**WATTS BAR NUCLEAR PLANT (WBN) UNIT 1 - REQUEST FOR ADDITIONAL
INFORMATION FOR END-OF-CYCLE 6 STEAM GENERATOR INSERVICE
INSPECTION REPORTS (TAC NO. MC7485)**

WATTS BAR NUCLEAR PLANT (WBN) UNIT 1
REQUEST FOR ADDITIONAL INFORMATION
END-OF-CYCLE 6 STEAM GENERATOR
15 AND 90 DAY INSERVICE INSPECTION REPORTS

FIGURE 1

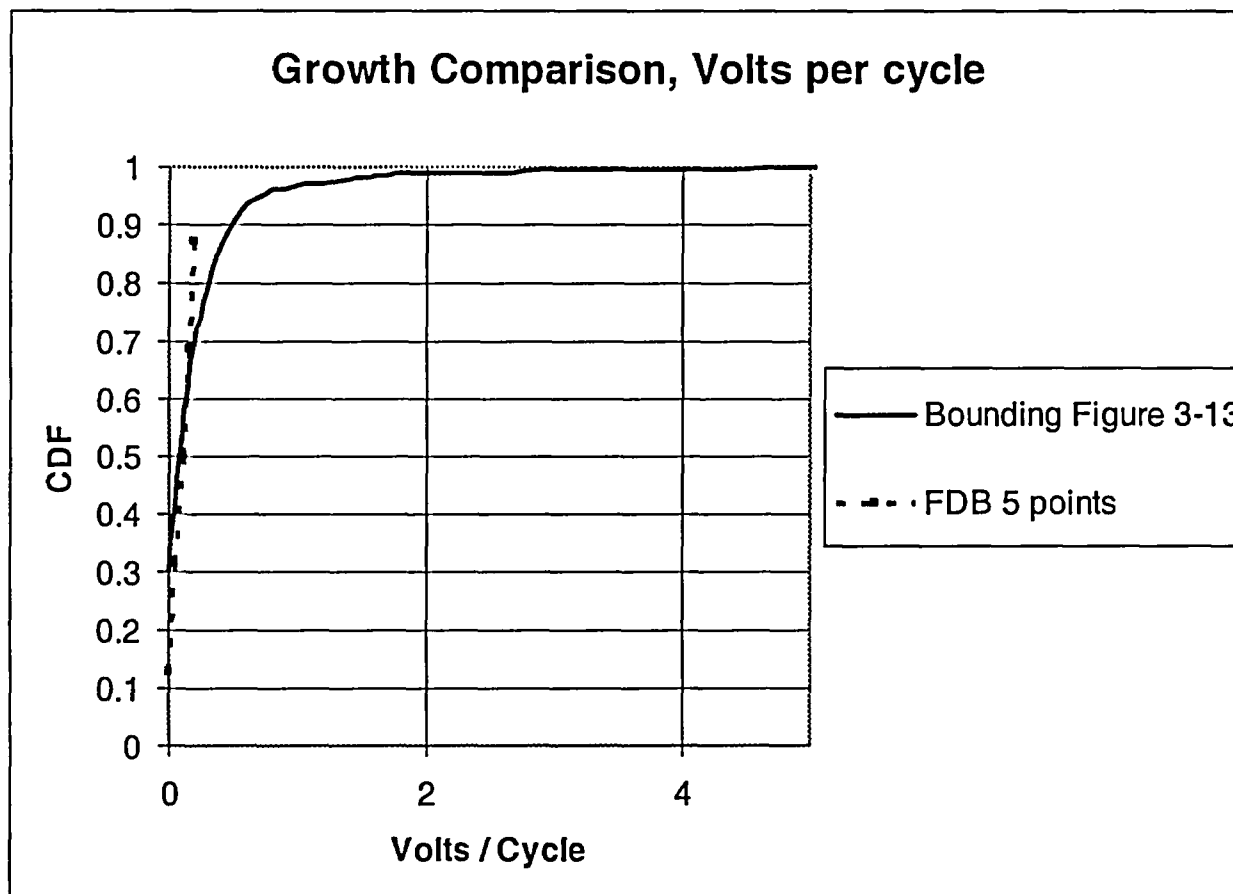
- a) That is, confirm that your amendment request addressed the causal factors for high voltage growth at flow distribution baffle intersections and the applicability of these conditions at your plant. Also,
- b) please discuss whether the average growth rates for the flow distribution baffle indications were less than that observed in steam generator 3 (although page 3-18 indicates that the average growth rates are less than that seen in steam generators 1 and 2, flow distribution baffle indications were found in steam generators 1, 2, and 3). If not, please discuss the implications.

A better demonstration of the observation that the growth rates are not considerably different is a comparison with the bounding cumulative distribution of the growth rate in the four steam generators shown in Figure 1 below and in Figure 3-13 in the June 28, 2005 report. Also shown is the cumulative distribution of the FDB indications conservatively adjusted by Benard's approximation equation (Note 1) because of the small number of data points.

From the figure, it is clear that the growth rate of the FDB indications is not considerably different from the growth rate of the TSPs.

FIGURE 6-2
3/4-INCH BURST PRESSURE CORRELATION

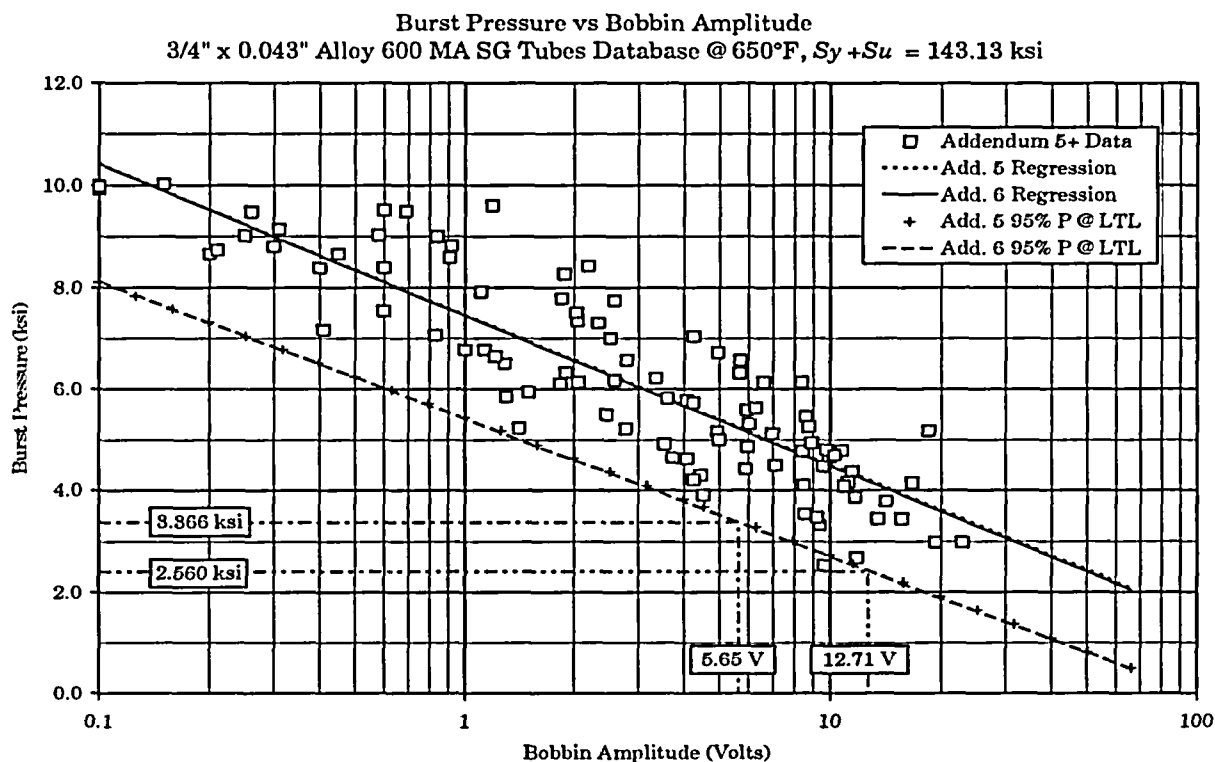
One tube was identified with a 6.32 volt indication. Please discuss what actions, if any, were taken to ensure that this tube had adequate structural integrity since the voltage exceeded the structural limit of 5.65 volts.

There is no requirement to do single-tube structural integrity calculations. The requirement in GL 95-05 is for a probability of burst for the bundle. This indication was included in the bundle analysis, and the steam generator met structural

performance criteria. Therefore, no additional actions were taken. If a single tube is of interest, according to Figure 6-2 of Addendum 6 of EPRI Report NP-7480-L shown below, an indication greater than 12 volts would be expected to meet the steam line break pressure with 95 percent probability using 95/95 lower tolerance limit material properties. The 5.65 limit in the Addendum is used as an upper bound repair limit. Above this limit, rotating coil examination cannot be used to keep the indication in service. Below this limit, if rotating pancake coil (RPC) does not confirm the indication, the tube can be left in service.

The voltage distributions of the new indications are shown in Figures 1 through 4 for Steam Generators 1 through 4 respectively.

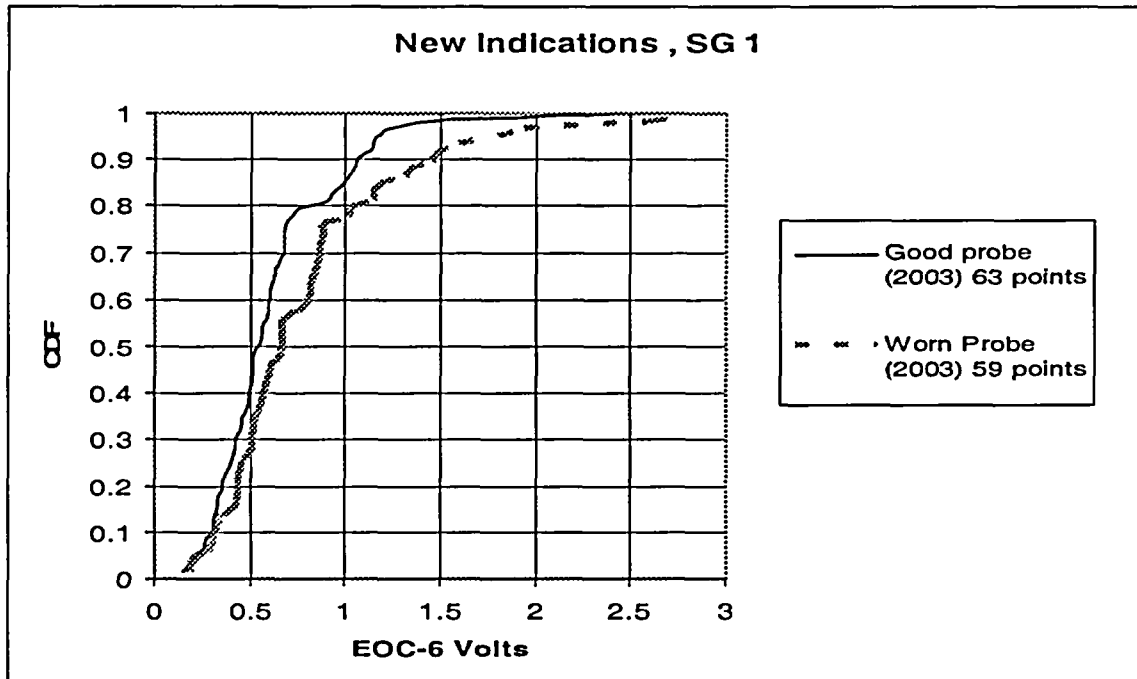
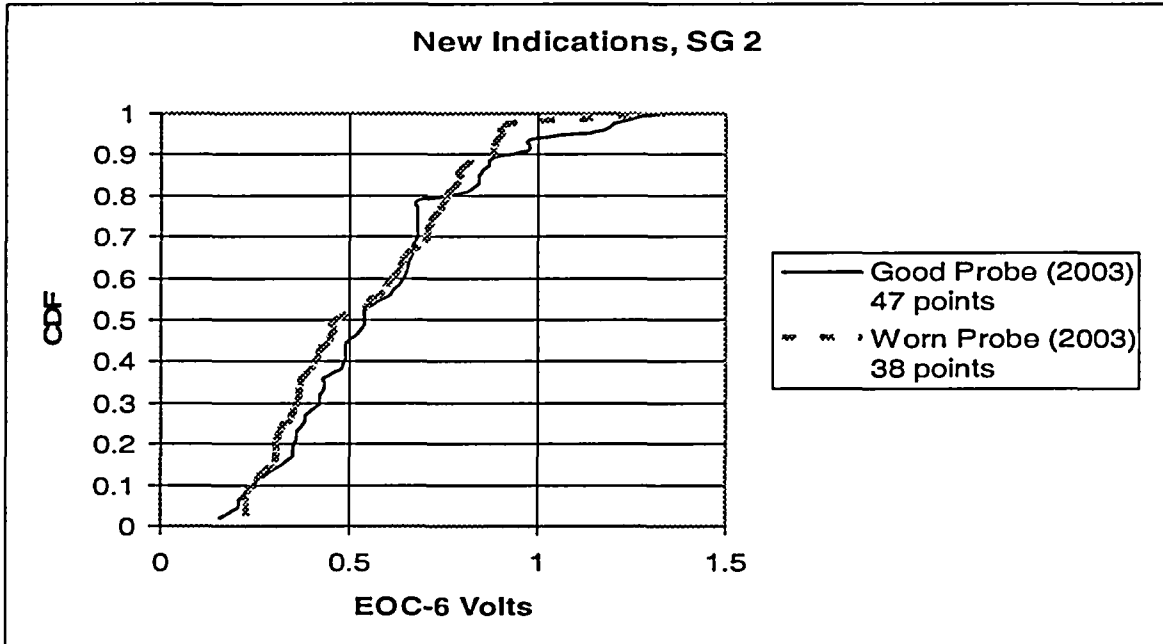
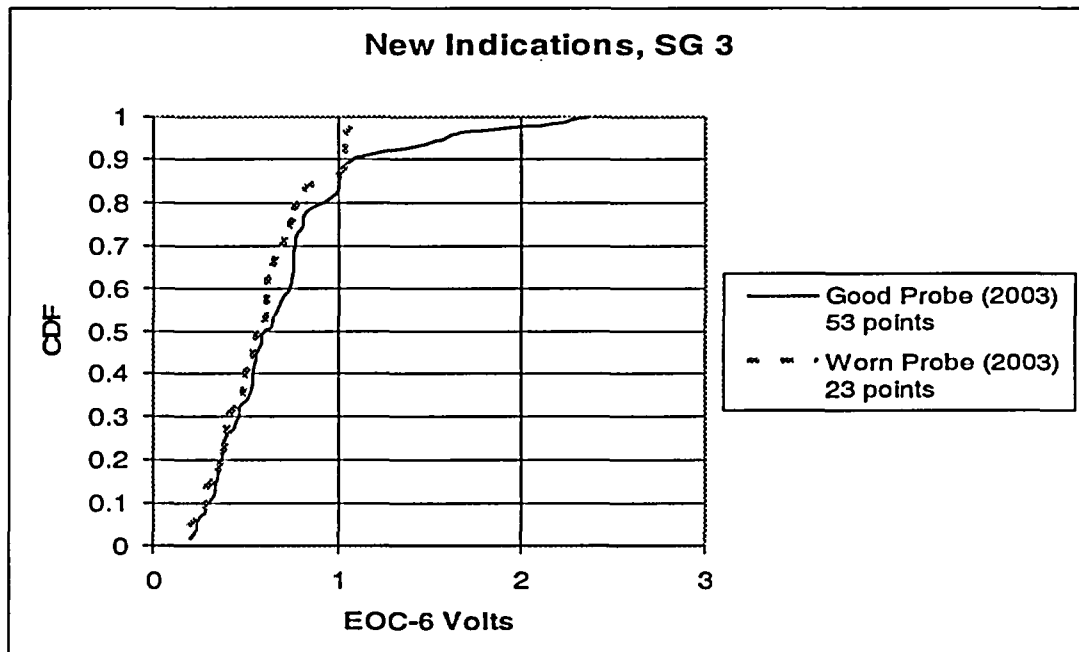
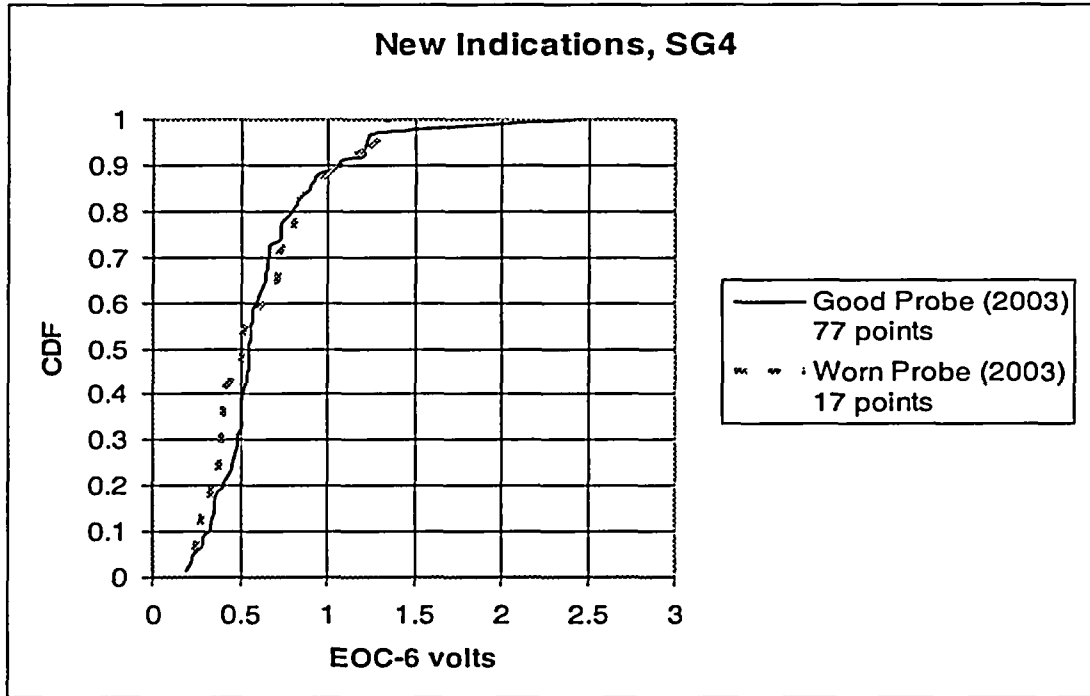
Section 4.7 provides an assessment of the probe wear criteria used at Watts Bar. In a portion of this assessment, the ratio of the current number of indications greater than 1 volt to the total number of these indications that were inspected with a worn probe in the previous inspection was compared to the ratio of the number of indications greater than 1 volt to the total number of indications in the current inspection. Based on similar ratios, a conclusion was drawn that there was no significant effect of probe wear on the population of indications. The staff notes that such a comparison is only valid if the number of tubes inspected with both a worn and good probe is comparable. That is, if the number of tubes inspected with worn probes is significantly different from the number of tubes inspected with a good probe, an erroneous conclusion may be made with respect to the adequacy of the probe wear criteria. As a result, please compare the percentage of new indications at the end-of-cycle (EOC) 6 that were inspected with a worn probe during the EOC-5 inspection to the percentage of new indications that were inspected with a good probe during the EOC-5 inspection. In addition, please compare the percentage of new indications greater than or equal to 0.5 volts during the EOC-6 inspection that were inspected with a worn probe during the EOC-5 inspection to the percentage of new indications greater than or equal to 0.5 volts during the EOC-6 inspection that were inspected with a good probe during the EOC-5 inspection. If there are significant differences, please provide an assessment of the adequacy of the probe wear criteria and its impact on your operational assessment for EOC-7. Calculation of the above percentages requires the

These observations indicate that there is not a significant difference in the rate of detection of new indications in tubes previously tested with worn probes or good probes.

The voltage magnitude of the new indications in tubes previously tested with worn probes and good probes is essentially the same as seen in Figures 1 through 4. This further supports the position that significant differences in results are not occurring due to previous testing.
